Subject: Requesting Class II permissive change for FCC ID: 2BCGWF65WALL

The purpose of this letter is to request a Class II Permissive change for FCC ID: 2BCGWF65WALL, original granted on 03/29/2024.

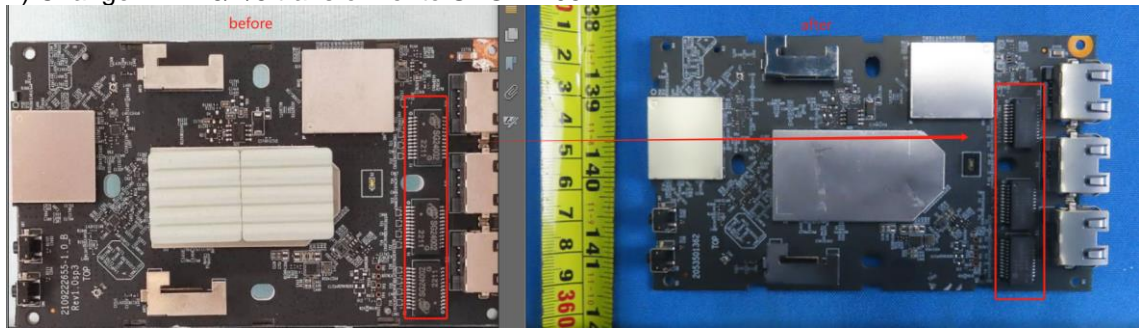
- 1) Change P02 block diagram transformer to UTG24P05, change DC-DC to SCT2620

2) Change P12 T6/7/8 transformer to UTG24P05
